# Summary of GTR19 Amendment 2

**7<sup>th</sup> Jan., 2019**

**Mayumi "Sophie" Morimoto (JASIC)**

Alternative equation for variable-volume SHED

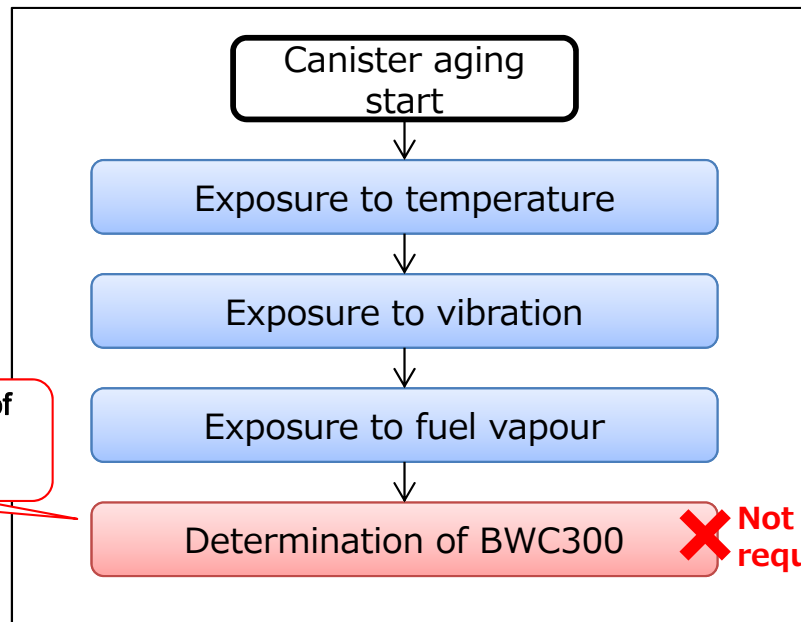
EPA / CARB : For SHEDs using Volume Adjustment e.g Moving Roof or Internal or External Bags

Assuming no gas is removed during the test, the volume at test start Temp and Press conditions (number of molecules) must remain the same as at the start of the test

$$M_{HC} = k \times V \times \frac{P_i}{T_i} \times (C_{HCf} - C_{HCi})$$

# Carbon canister aging and its installation to vehicle

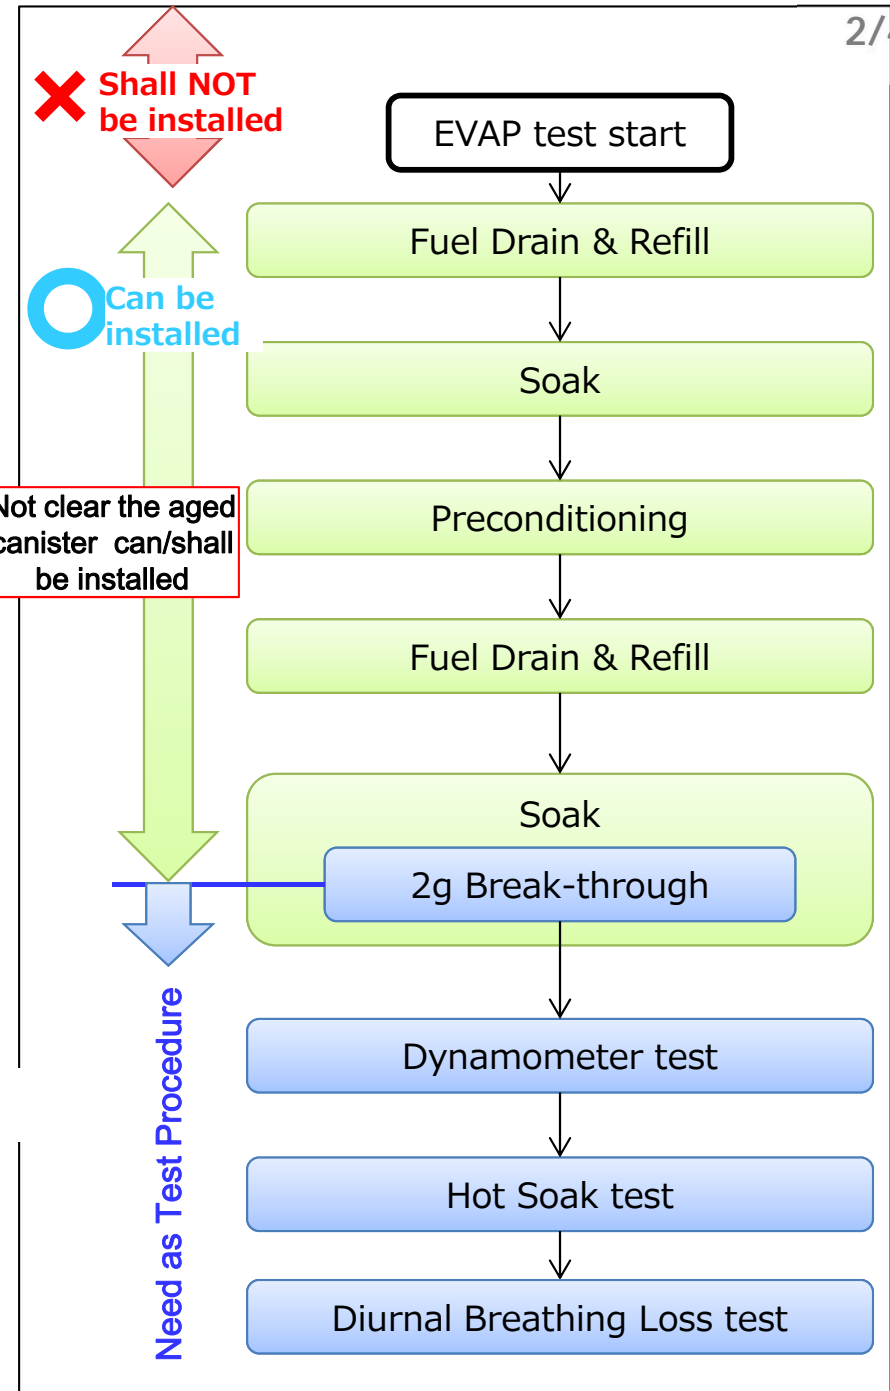
- The aged carbon canister shall not be installed during the run-in or before the start of test procedure flow chart.
- The carbon canister aging will need the temperature exposure, vibration exposure and fuel vapour exposure.

(No determination of BWC300 is required)

Not clear determination of BWC300 is included in canister aging

Not required

**Clarified texts concerning the aged carbon canister.**
